CrystaliteTM Inc.
SKYLITES • SUNROOMS • RAILINGS

JOB NAME:	DEALER NAME:	P.O. #	PROJECT #	SHEET #	DATE:	DRAWN BY:
	BMC WEST	9440NH	C-10812	1	10.28.19	ALEX S.

Reviewed for code compliance
with IRC 2015
Kitsap County Building Department
GShapiro@co.kitsap.wa.us
05/29/2020

B/2 SKYLIGHT HEAD DETAIL

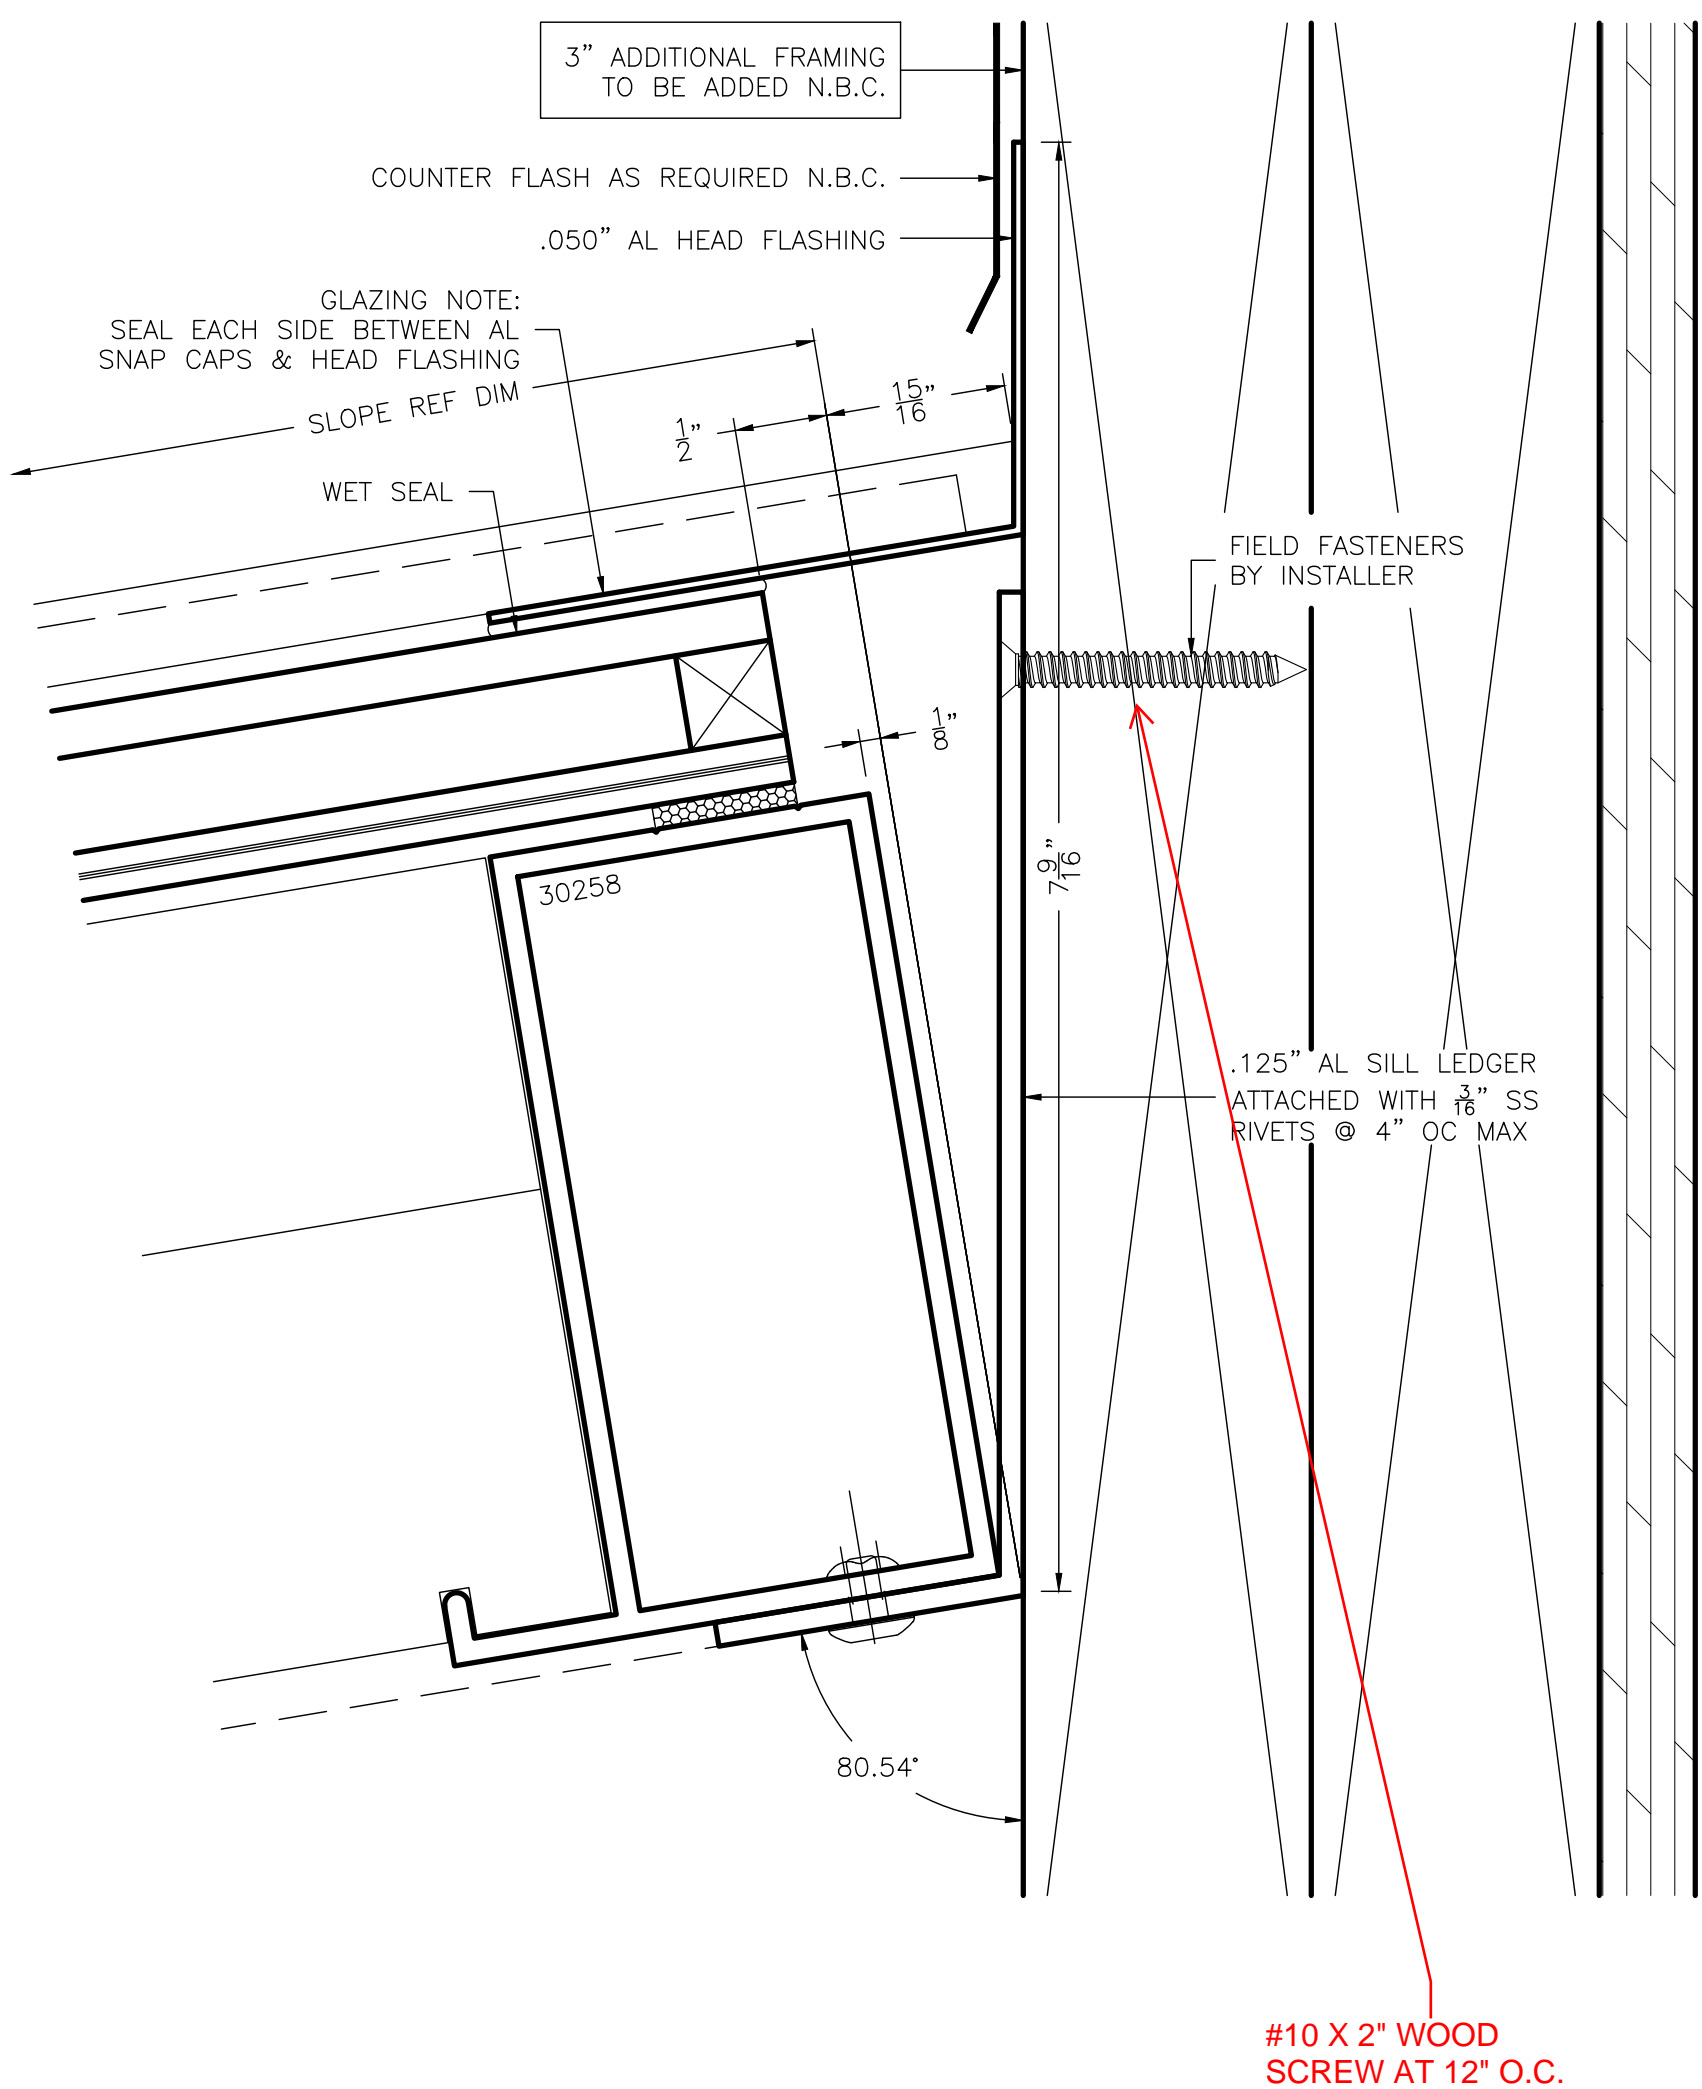
As per first request
provide concrete slab
and curb detail, show
how bottom plate will
be connected to curb
